**ZONING AMENDMENT,
PLANNED UNIT DEVELOPMENT &
SUBDIVISION STAFF REPORT****Date: August 20, 2015****NAME**

Highland at Springhill Subdivision

121 West I-65 Service Road North
(West side of West I-65 Service Road North extending to
the South side of South Avenue extending to the Northeast
corner of College Lane South and Du Rhu Drive)

Subdivision approval to create 2 legal lots of record,
Planned Unit Development Approval to allow multiple
buildings on a single building site, and Rezoning from B-1,
Buffer-Business District, and B-3, Community Business
District, to B-1, Buffer-Business District, to eliminate split
zoning.

SITE PLAN

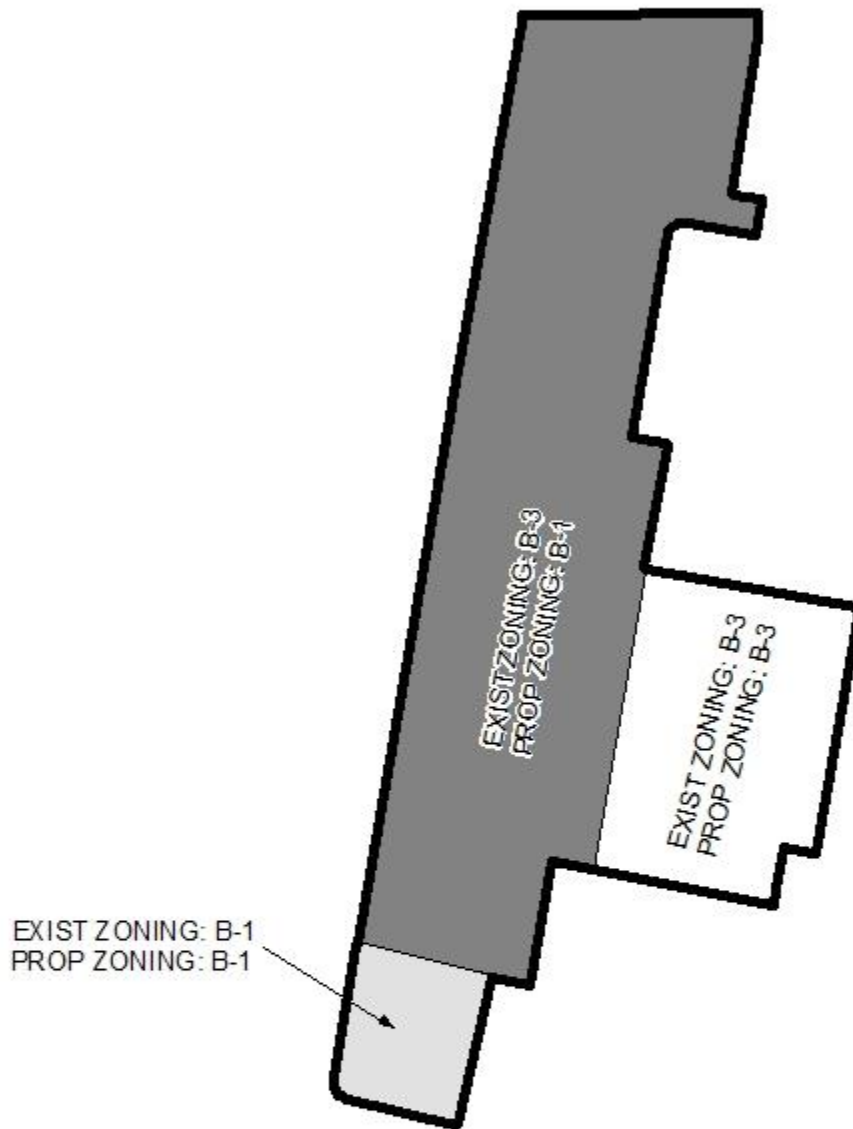
The site plan provided shows one curb cut at the Northern terminus of Spring Hill Business Park and one curb cut to Du Rhu Drive. As a means of access management, a note should be required on the Final Plat, if approved, stating that the development is limited to one curb cut to Spring Hill Business Park and one curb cut to Du Rhu Drive, with the size, location and design to be approved by Traffic Engineering and conform to AASHTO standards. The site plan illustrates sidewalks along all frontages.

The site plan states the site will have 252 dwelling units and should therefore should have a minimum of 378 parking spaces. The site plan submitted illustrates 443 parking spaces. It should be noted that parking lot lighting should be provided in compliance with Section 64-6.A.8. of the Zoning Ordinance.

The applicant proposes to have gates at both entrances, but does not state if they are manual or electronic. The site plan should be revised to clarify if the gates are manual or automatic, and if they are manual, provide queuing spaces in compliance with Section 64-4.F.2. of the Zoning Ordinance.

The proposed site plan indicates a trash compactor will be provided on the site, but does not mention if it will be connected to sanitary sewer or be enclosed. If approved, the site plan should be revised to indicate the compactor will built be in compliance with Section 64-4.D.9. of the Zoning Ordinance.

- 3) placement of a note on the site plan stating that parking lot lighting will comply with Section 64-6.A.8. of the Zoning Ordinance;
- 4) retention of the sidewalk along all frontages;

- 5) placement of a note stating that the lot is limited to one curb-cut to Du Rhu Drive and one curb-cut to Spring Hill Business Park, with the size, design, and location to be approved by Traffic Engineering, and to comply with AASHTO standards;

- 6) revision of the site plan to either state the proposed gates are electronic, or manual with appropriate queuing spaces per Section 64-4.F.2. of the Zoning Ordinance;

- 7) revision of the site plan to state that the proposed trash compactor will be connected to sanitary sewer and enclosed per Section 64-4.D.9. of the Zoning Ordinance;

DETAIL SITE PLAN

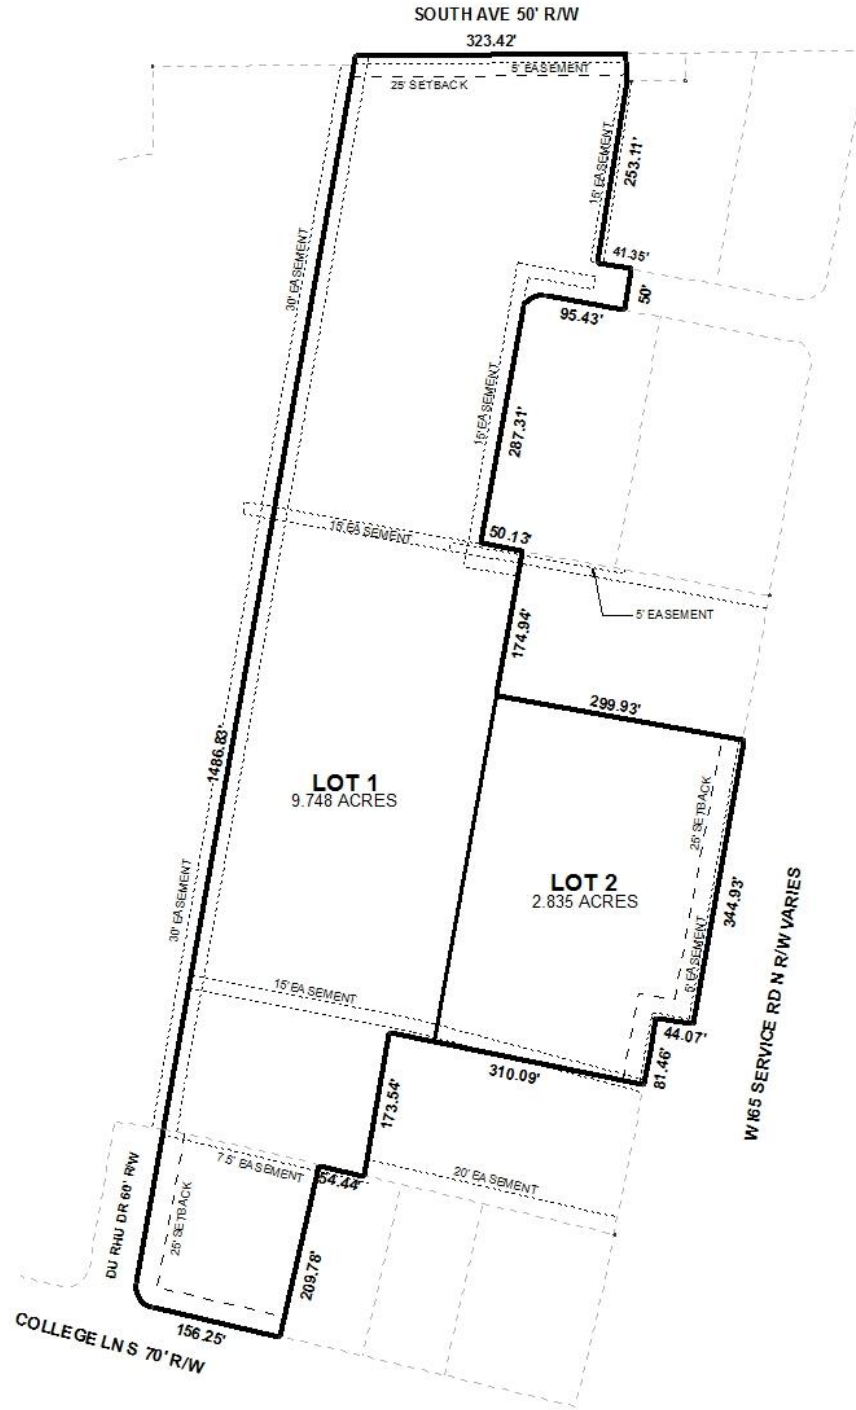
The preliminary plat illustrates the 25' minimum building setback line along all frontages except Spring Hill Business Park. If approved, the Final Plat should be revised to illustrate the minimum building setback along all frontages.

The preliminary plat indicates the presence of Alabama Power, MAWSS, and drainage easements on the site. A note should be provided on the Final Plat stating that no structures will be built in any easement.

- 4) *illustration of the 25' minimum building setback line along all frontages;*
- 5) *retention of a note stating the lot size in square feet and acres;*
